UNITED STATES PATENT AND TRADEMARK OFFICE

APPLICATION NO.	FILING DATE	FIRST NAMED INVENTOR	ATTORNEY DOCKET NO.	CONFIRMATION NO.
09/615,794	07/13/2000	Dong-Gyu Kim	06192.0141.NPUS00	5256

Office Action Summary

DETAILED ACTION

FIG. 10

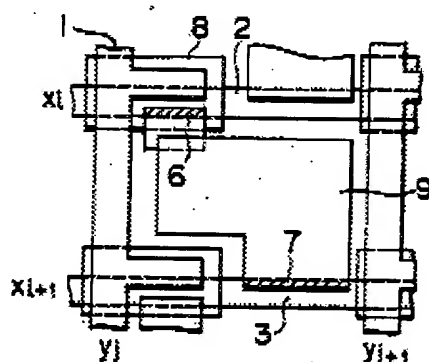
As to claims 1-3, Tsukada discloses in Figure 10 his fourth embodiment (col. 8, lines 38-62) a liquid crystal display, comprising:

a pixel demarcated by the gate lines and the data lines (per Figure 10), the gate lines demarcating the pixels into rows, and the data lines demarcating the pixels into columns;

Tsukada does not explicitly disclose a black matrix defining each pixel; wherein an opening ratio of each pixel at the first pixel row is different from the opening ratio of the pixels at the other pixel rows.

FIG. 6

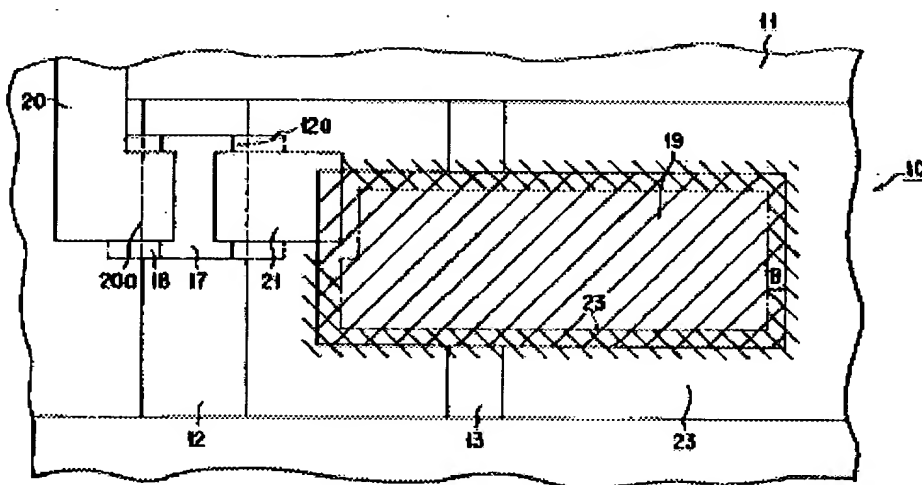
Dohjo teaches, in Figures 6 and 5, the use of a protecting film, 23 (Applicant's black matrix), wherein an aperture ratio is lowered in the peripheral portions of the display near the sealant and near the closing agent (Applicant's opening ratio of each pixel at the first pixel row is different from the opening ratio of the pixels at the other

pixel rows) to prevent the development of deterioration of image quality of the peripheral portions while preventing a lowering of the aperture ratio of the main display pixel electrodes (col. 9, line 58 through col. 10 line 5).

Dohjo is evidence that ordinary workers in the art of liquid crystals would find the reason, suggestion, or motivation to add a black matrix, wherein an opening ratio of each pixel at the first pixel row is different from the opening ratio of the pixels at the other pixel rows to prevent the development of deterioration of image quality of the peripheral portions while preventing a lowering of the aperture ratio of the main display pixel electrodes.
